## Redesign Thermo Steuergeräte SG 1572D | 97821A → 97821B, .... | EN/DE - Id.No PCN-2024-010

### Product Change Notification (PCN)

PCN-2024-010 EN / Rev. 2 16.09.2024

#### Redesign Thermo control unit - ECU 1572D

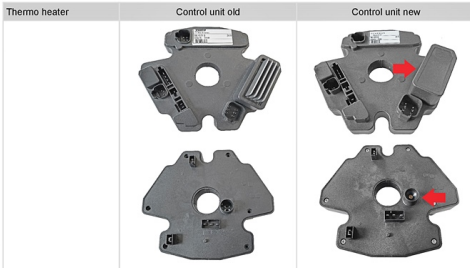
Reasons for change: Component discontinuation on PCB of the Thermo control unit.

- Effects:
- Changed appearance due to additional housing cover.
  - Flame monitor is now integrated into the control unit. When replacing a control unit, the previous flame guard is no longer required.
  - All identification numbers of Thermo control units increase in the index.

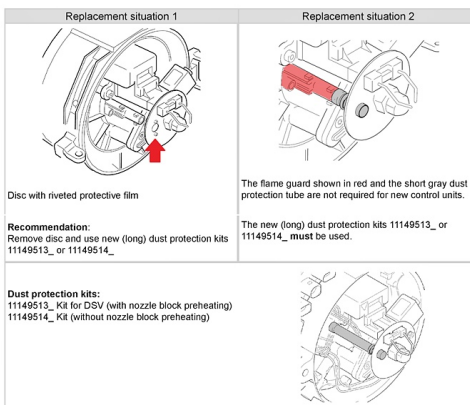
Interchangeability: When using the old (short) dust protection kits 11136322\_ or 11136323\_ the new (long) dust protection kits 11149513\_ or 11149514\_ must be used. When using disc with riveted protective film (see illustration below), we recommend using the new (long) dust protection kits 11149513\_ or 11149514\_.
